**CITY OF SAN ANGELO
SAN ANGELO LANDFILL
TOM GREEN COUNTY, TEXAS
TCEQ PERMIT NO. MSW 79**

**SITE DEVELOPMENT PLAN
AND
PERMIT MODIFICATIONS
(THROUGH DECEMBER 2013)**

Modification to Municipal Solid Waste Permit No. 79 San Angelo Landfill

MODIFICATION TO MUNICIPAL SOLID WASTE PERMIT NO. 79 CITY OF SAN ANGELO LANDFILL

DRAWING
94-02

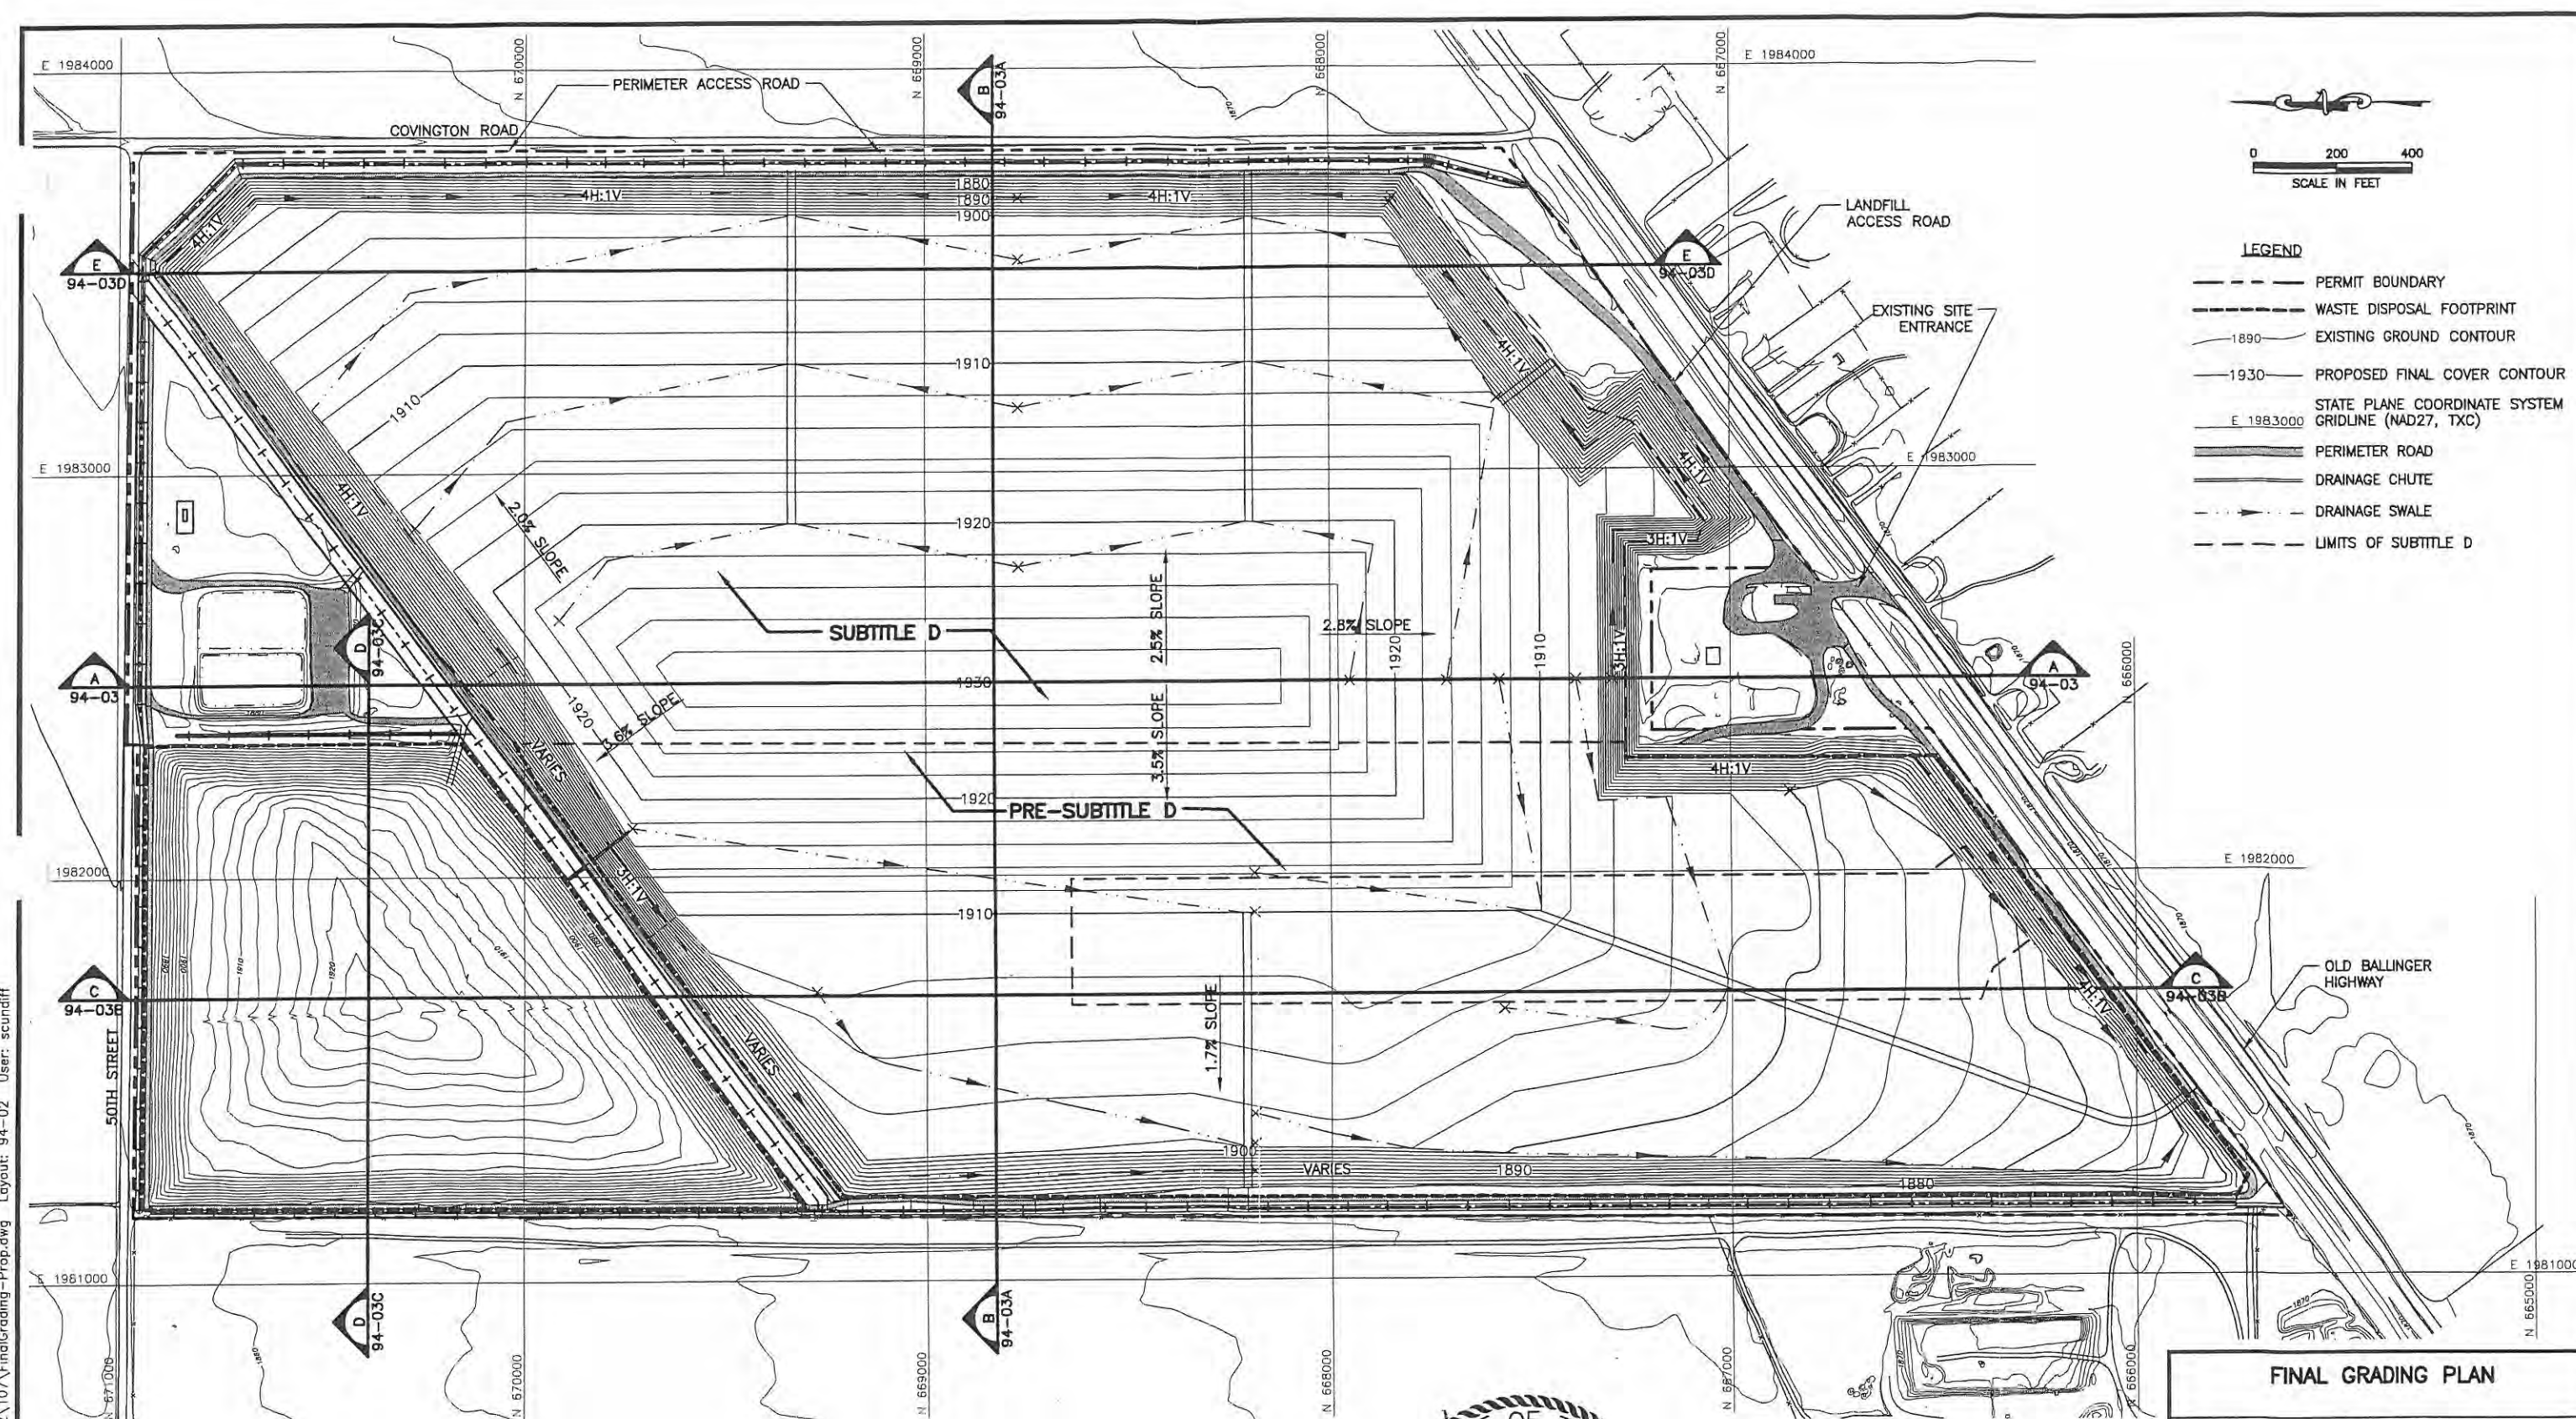
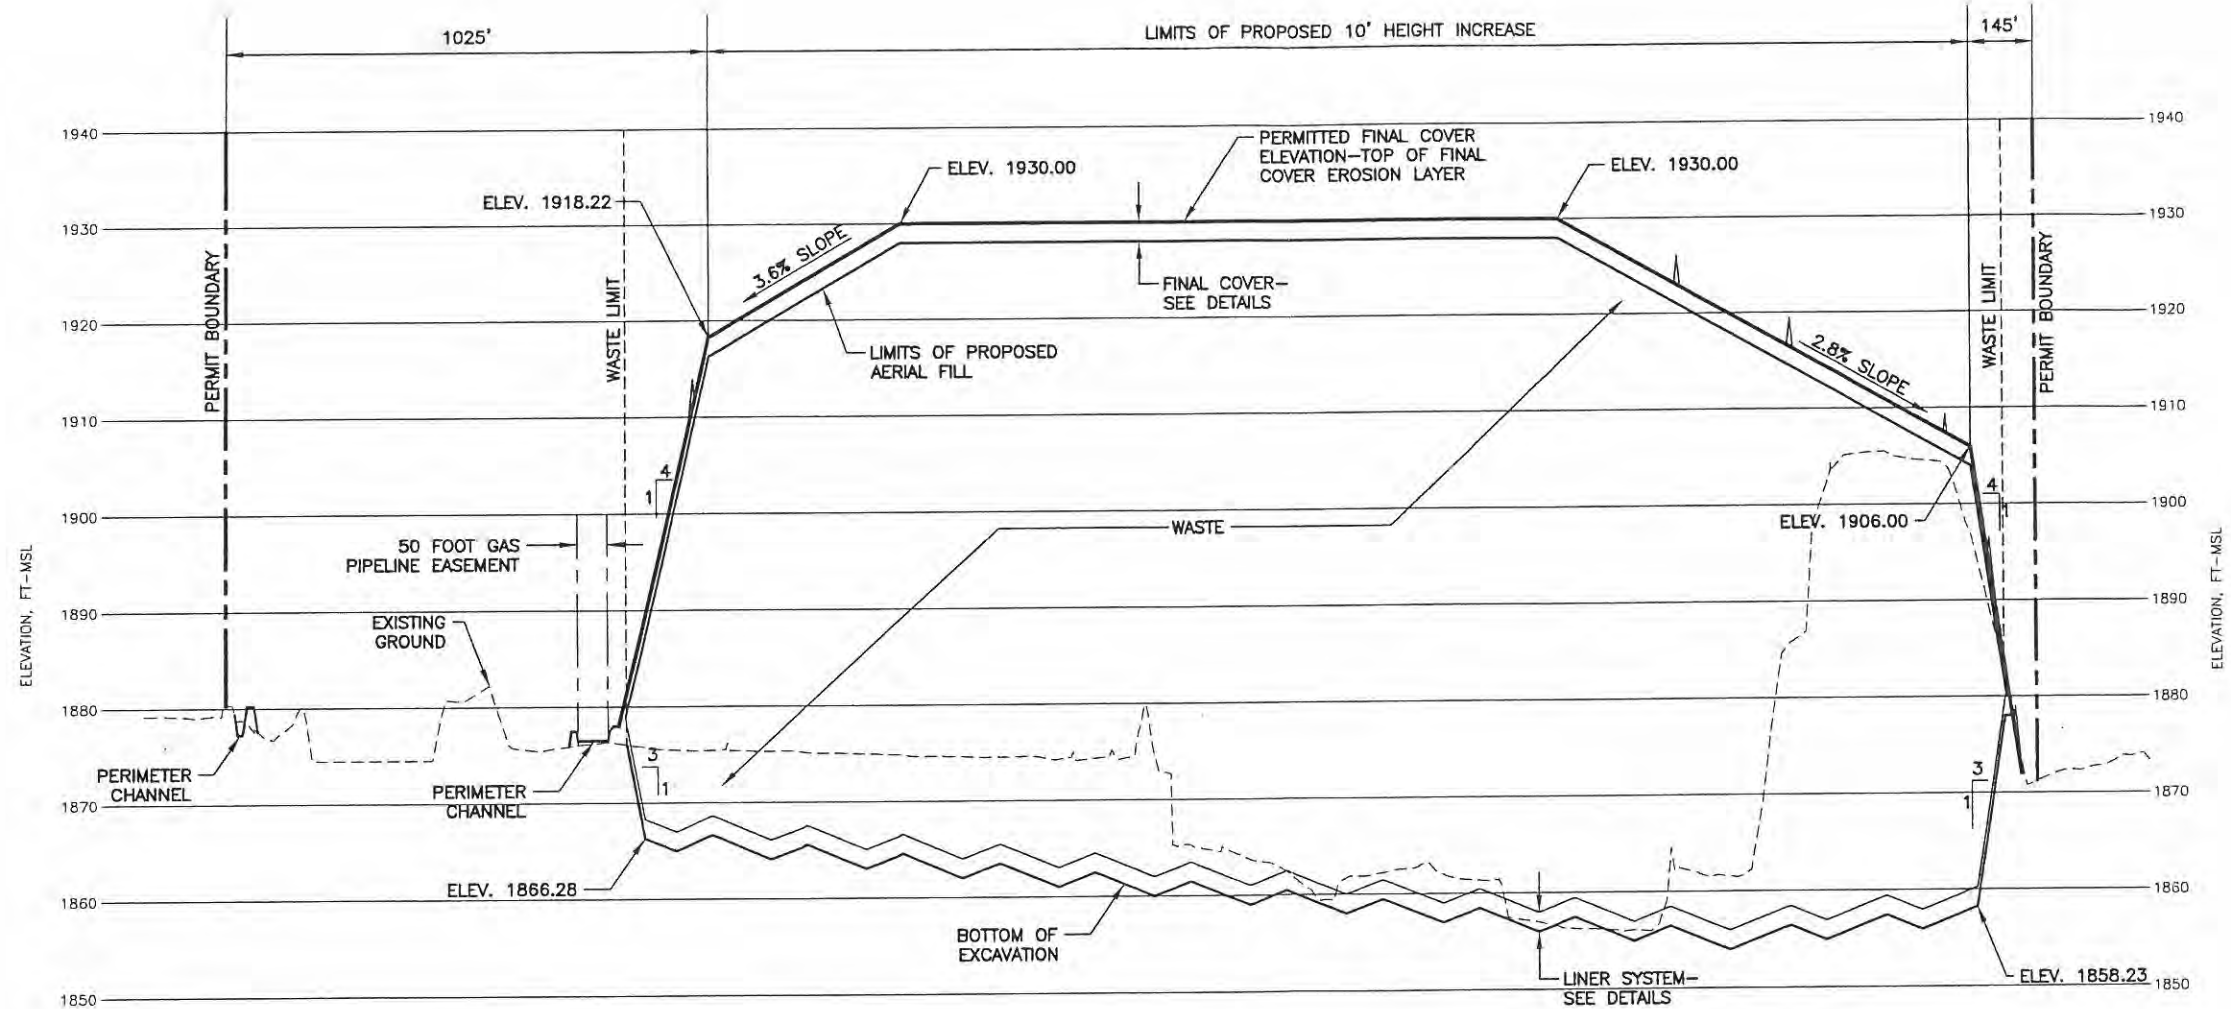
Modification of the Site Development Plan to revise the final contours and increase the maximum height of the landfill by 10 feet, from 1920 feet above mean sea level (ft-msl) to 1930 ft-msl, to improve surface water drainage and to reduce the limits of waste area north of the gas pipeline from 41.5 acres to 31.9 acres, creating a reduced total waste disposal footprint of 225.2 acres.

Attachment 2, Drawings 94-02, 94-03, 94-03A, 94-08, are revised.

DSN.	ALN	DATE :	02/08	DRAWING 94-03B
DWN.	SRC	SCALE :	GRAPHIC	
CHK.	ALN	DWG :	FinalGrading-Sect.dwg

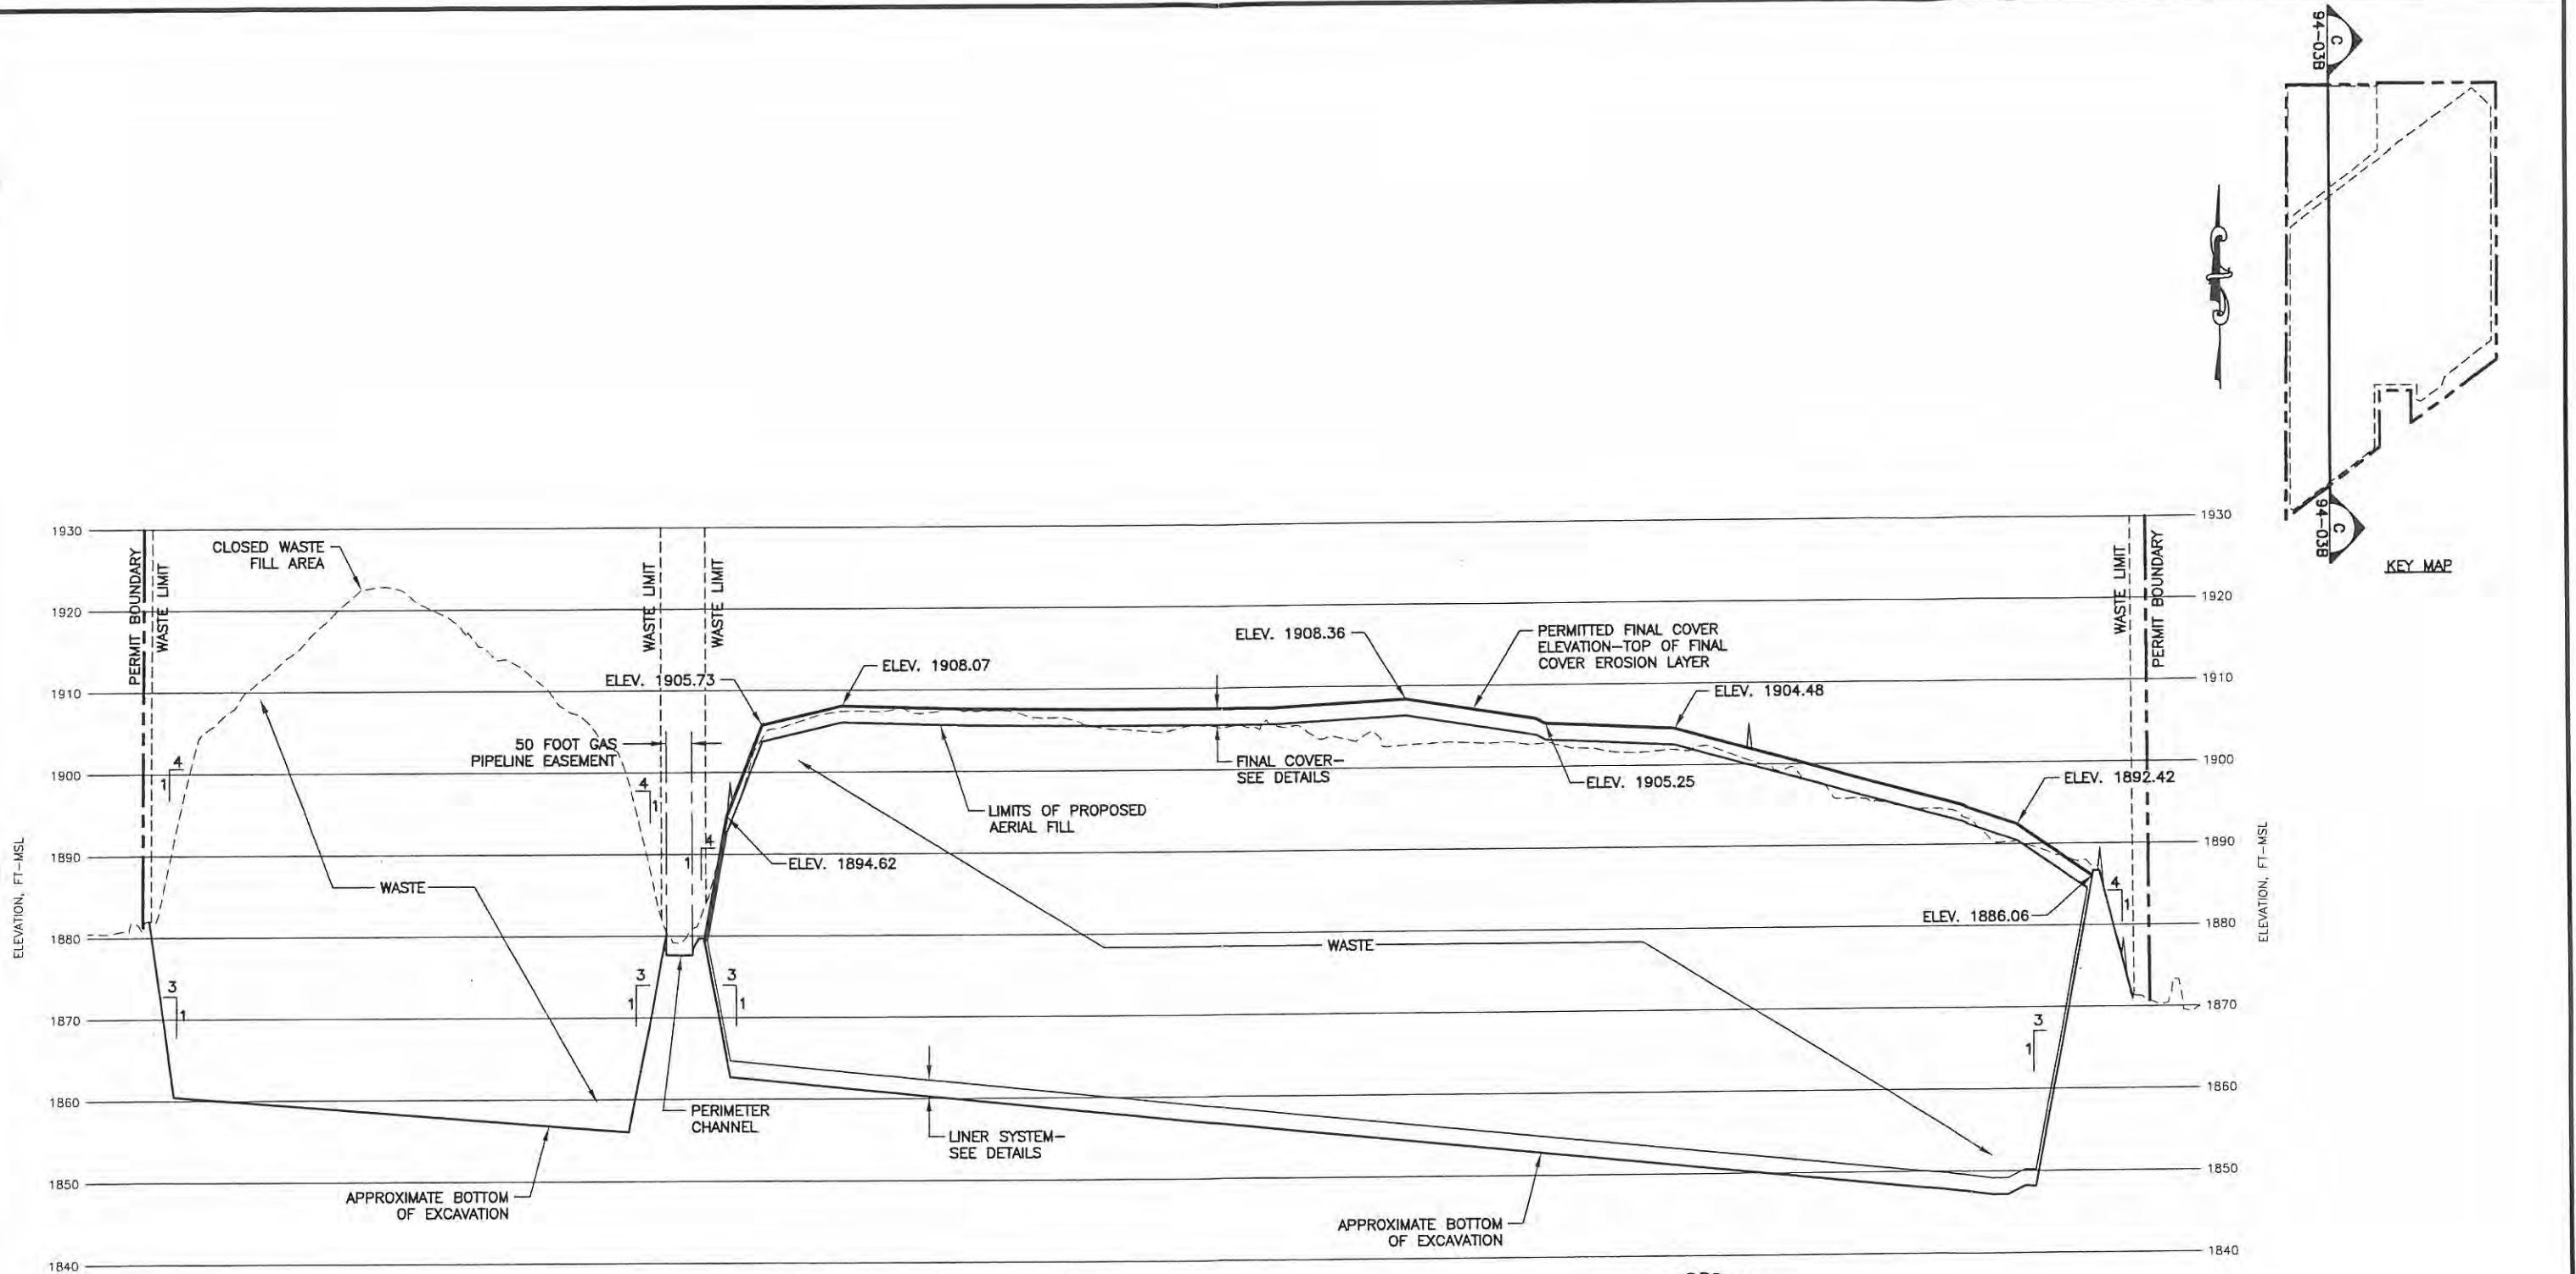
Attachment 2, Drawings 94-03B, 94-03C, 94-03-D, 94-08A are added new.
